Rezoning Transportation Analysis

Petition Number: 2024-143

Date	Description
1/22/25	First Review (CJM)
2/19/25	Second Review (CJM)
9/24/25	Third Review (CJM)
10/23/25	Fourth Review (CJM)

CLDSM U-05A1 Local Office/Commercial Wide

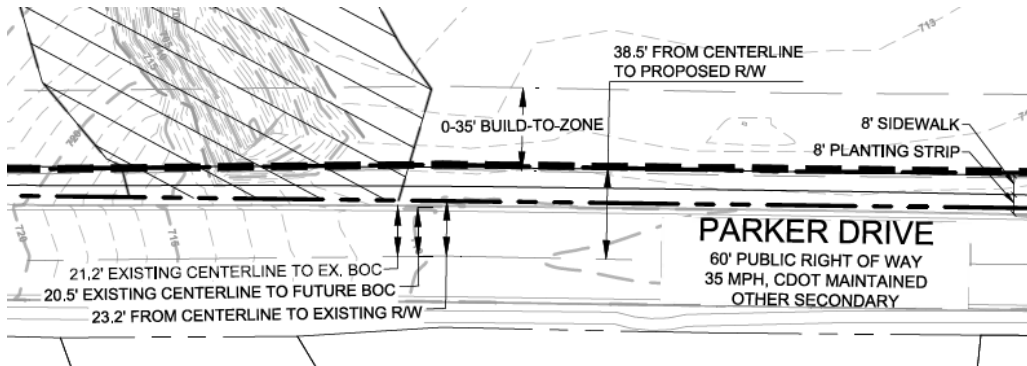
- b. ~~**Parker Drive:** Location of future back of curb and gutter to be installed 20.5' from centerline.~~

- c. ~~**Berryhill Road:** Location of future back of curb and gutter to be installed 20.5' from centerline.~~
